G.O. No.	421	Press
B.P. No.		Mis.
393-396		
Dated	20-2-1874	195

*Proceedings of the Madras Government, Public Works Department,
20th February 1874.*

I HAVE the honour to forward, for the sanction of Government, a plan and estimate of Rupees 160 for fixing curved iron bars on tops of screens in privies of the Royal Artillery Agram Barracks at Bangalore.

Plan showing the
iron bars proposed to be
substituted in place of
wooden bars on top of
screens in prisons belong-
ing to Royal Artillery
in Agar and Barracks
Bangalore.

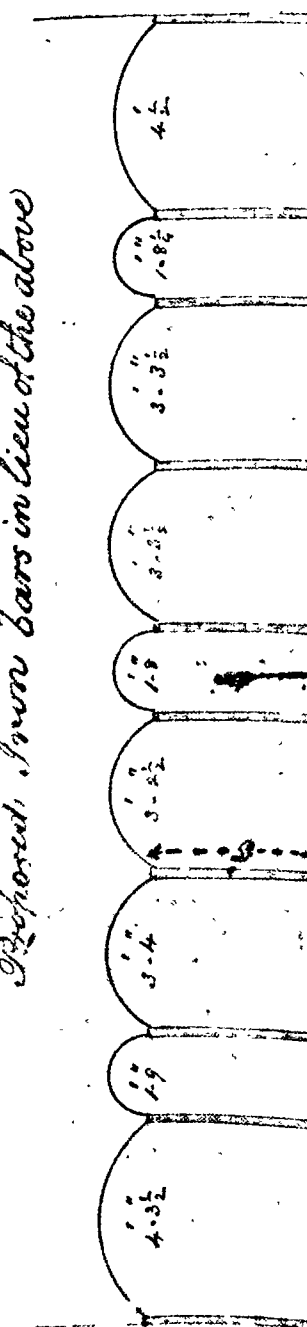
Proposed Iron Bars in lieu of the above

2. The object of the screens is to separate the seats one from the other. In order to keep the screens firm, straight wooden bars were fixed on tops of them, but as these straight bars are found to be inconvenient, it is proposed to remove them, and to replace circular curved,

curved, iron bars as shown on Plan, so as
to raise the height of the centre of the bars.

Sanctioned for
 execution from the Minor
 New Works allotment of
 the District in 1874-75.
 It would appear from
 the District Engr's letter
 to the Inspecting Engineer
 No. 244 of 19th December
 that a similar alteration
 is required to some privies
 connected with the Cavalry
 Barracks, which should
 also be attended to.
